Greater Cambridge Local Plan

Proposed Submission (Regulation 19) Consultation - Response Form

Proposed Submission Greater Cambridge Local Plan
Reg 19 of the Town and Country Planning (Local Planning) (England) Regulations 2012
Submission on behalf of Teversham Parish Council

Fig 1: CEAAP 2008

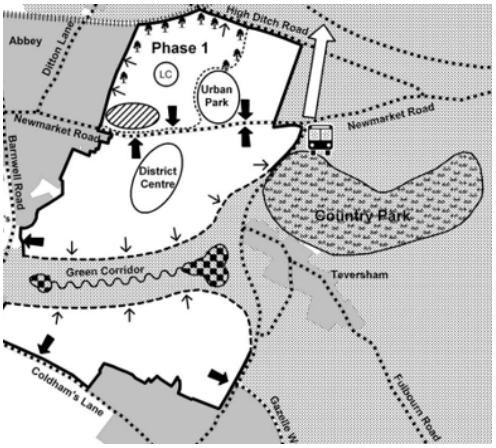
12 However, from the earliest plans a country park to the north of Teversham was also set out. This can be seen in the 2008 Cambridge East Area Action Plan (see Fig 1).

Fig 2: South Cambs LP 2018

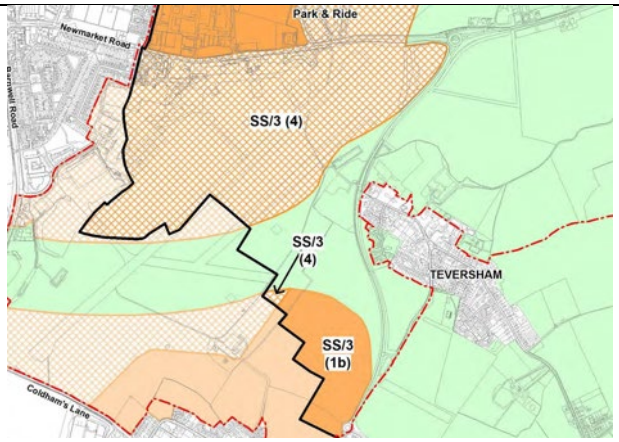
14 It was retained in the 2018 South Cambridgeshire Local Plan (see Fig 2).

Fig 3: GCLP Figure 53: Indicative Spatial Framework for S/CE: Cambridge East.

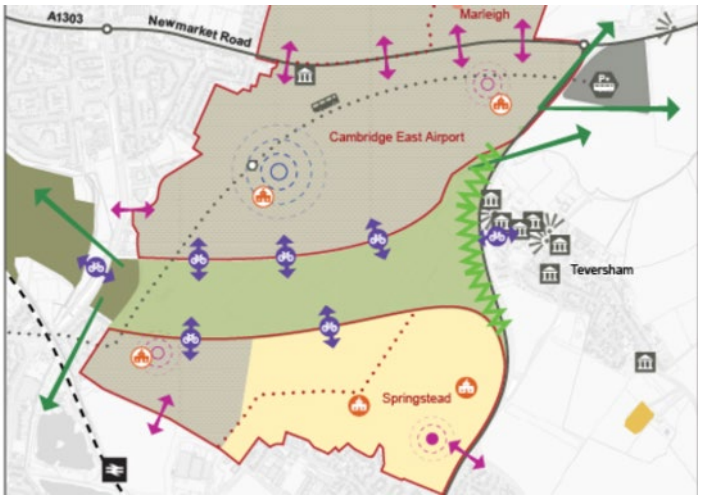
It is, however, entirely missing from the GCLP (see Fig 3).

15 The GCLP gives no explanation for its removal, nor has it been replaced with an alternative land use on policy maps. This omission does not fulfil the requirement to be "positive" in terms of land use enshrined in the four soundness principles.

16 Nor is this consistent with the GCLP elsewhere which requires the green corridor to "*Connect to strategic green infrastructure beyond the site*." Or "*ensuring that proposed green infrastructure is appropriate to its local contexts*", According to Figure 53 (our figure 3) there will be no green infrastructure to connect to save an aspirational linkage to the Wicken Fen Vision well north of the A14 trunk road and entirely separated from Teversham. TPC cannot comprehend how this complies with GCLP policy principles elsewhere in the consultation draft it also contradicts the design principles of

TPC fails to see how this can be satisfied if the country park is **not** provided.

18 TPC strongly considers the country park should be reinstated.
